CITY PLAN COMMISSION STAFF REPORT

CD-CPC-2025-00124, 00140

Martin City FlexCaves

- 2.1: Area Plan Amendment
- 2.2: Rezoning to MPD

Site Plan

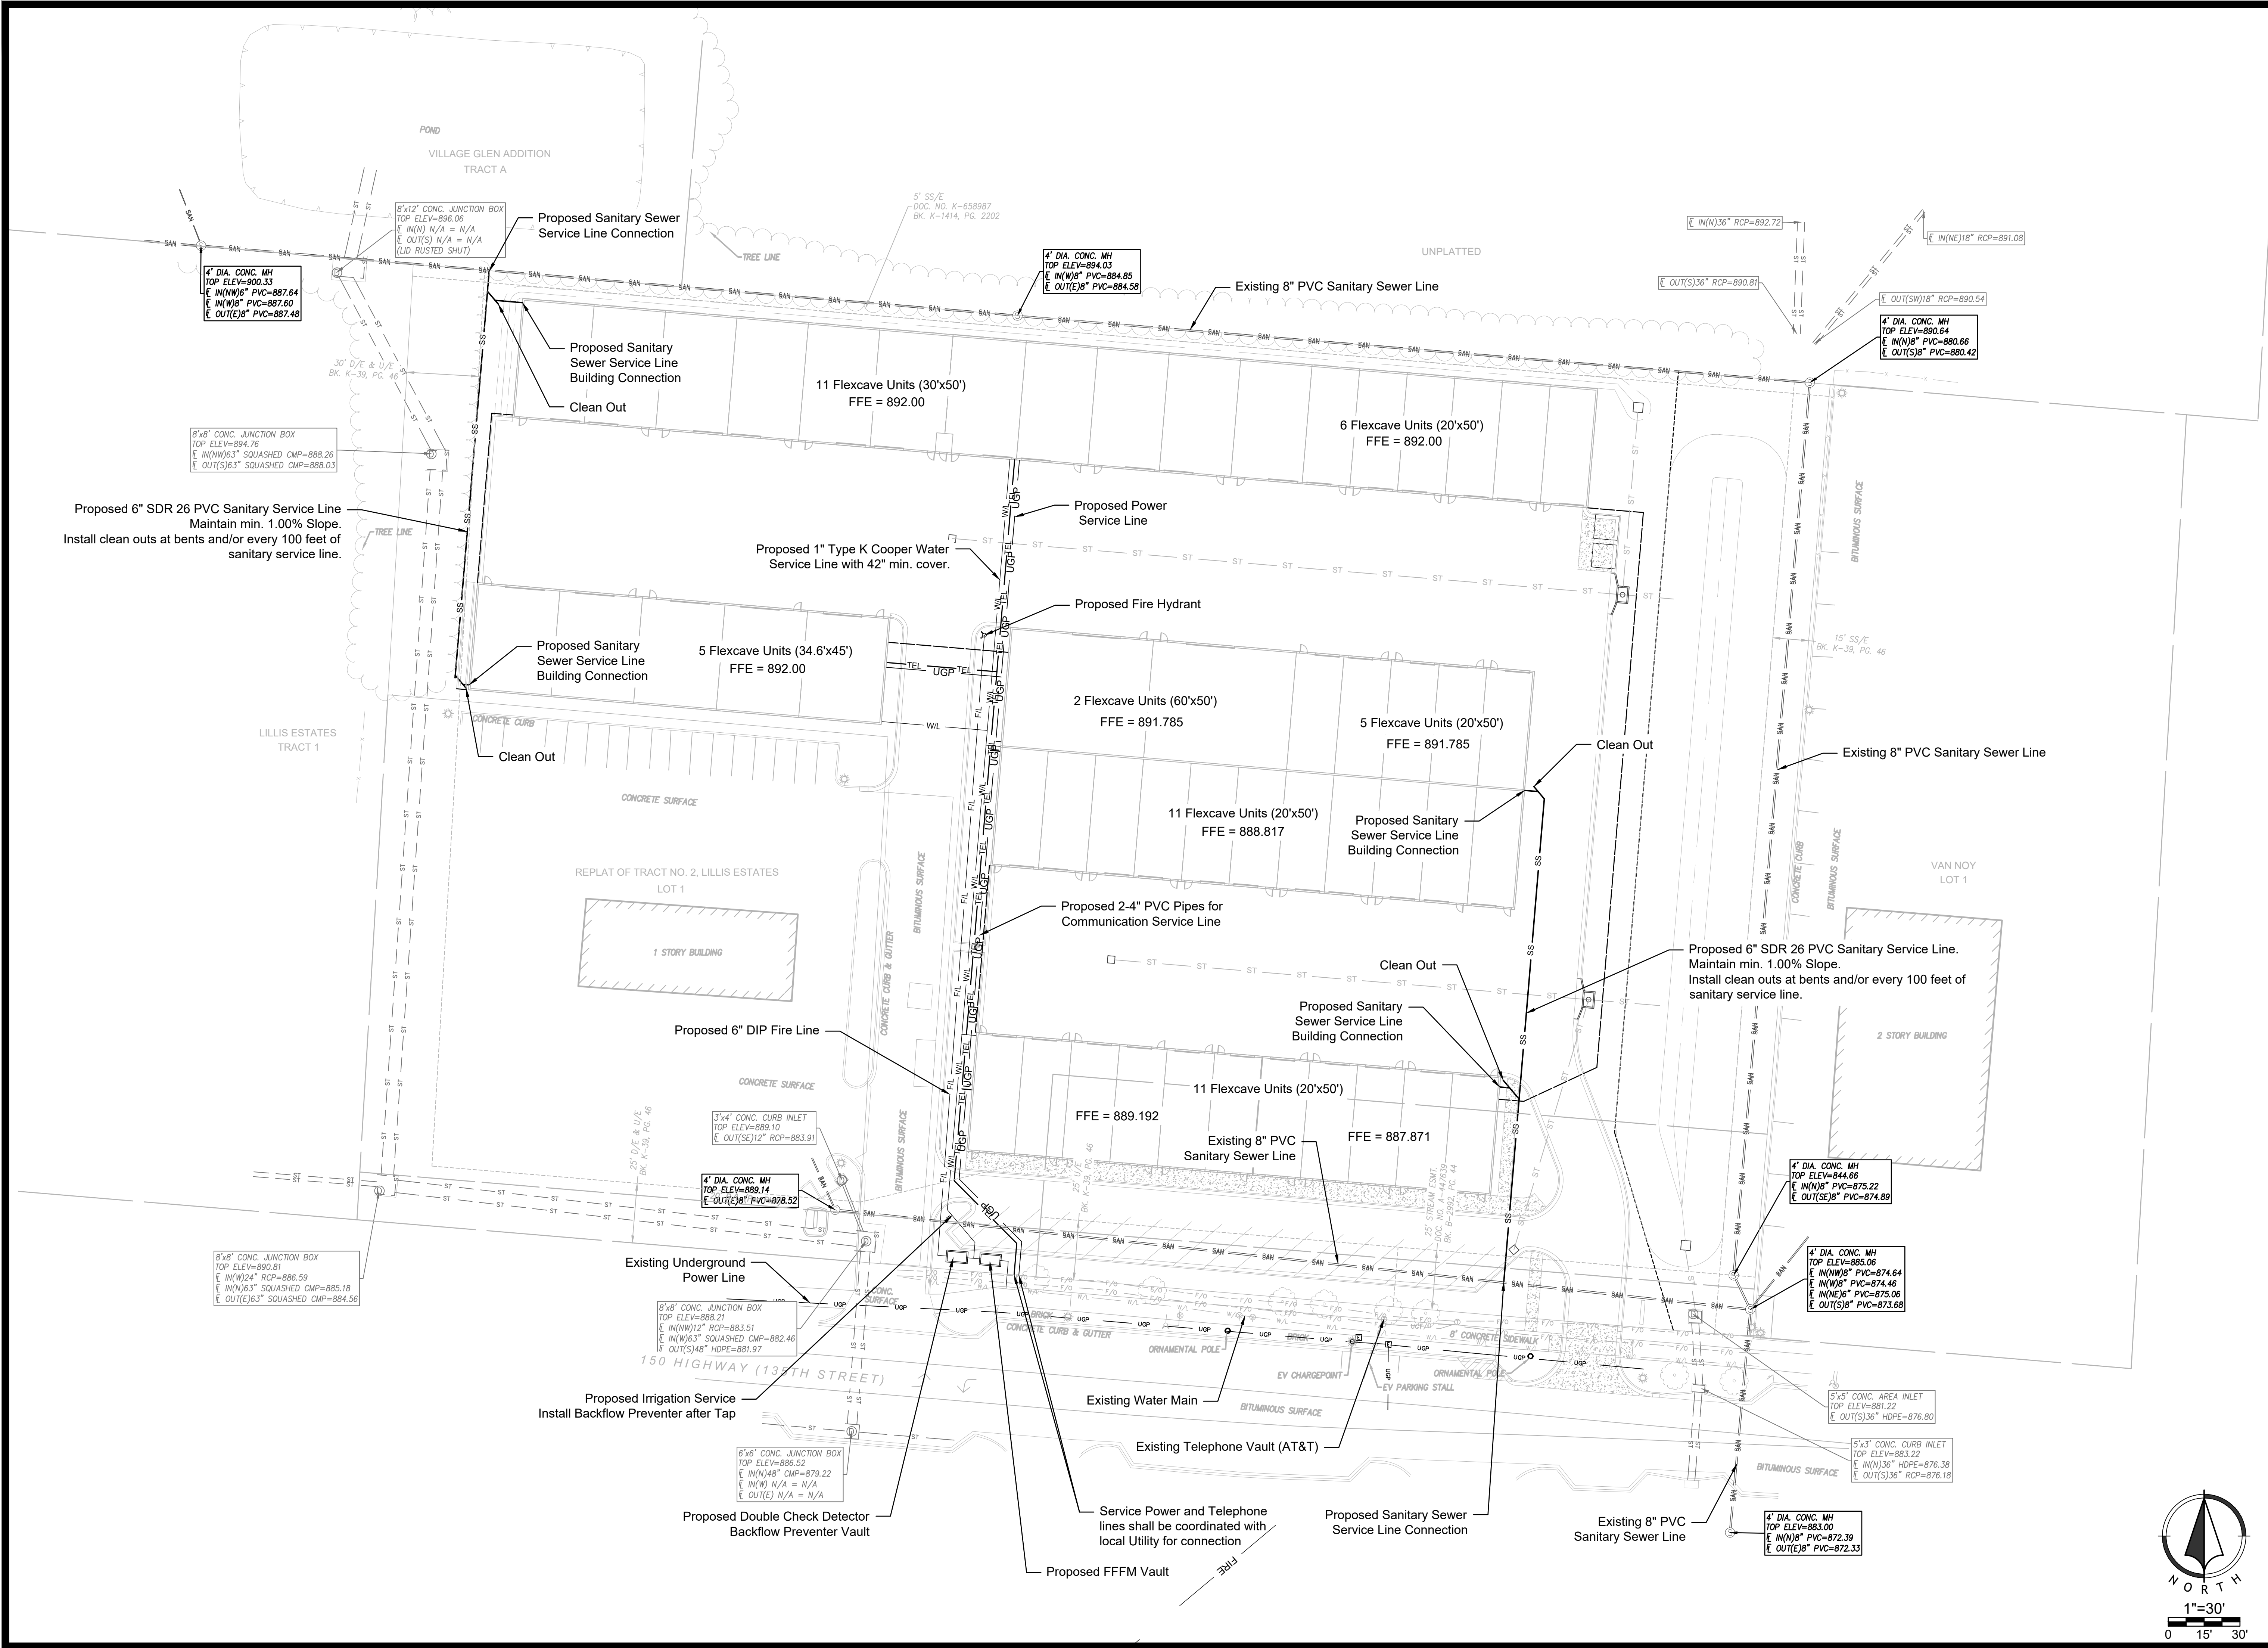
Staff requested that the applicant move the “ShopCaves” to the street and move the parking to the side to more closely align with the Area Plan and context of the corridor to the north. The applicant did not update plans; however they did provide additional screening of the parking area in the form of landscaping.

screen the parking from East 135th Street. A masonry wall was requested by staff to provide additional screening but was not provided by the applicant.
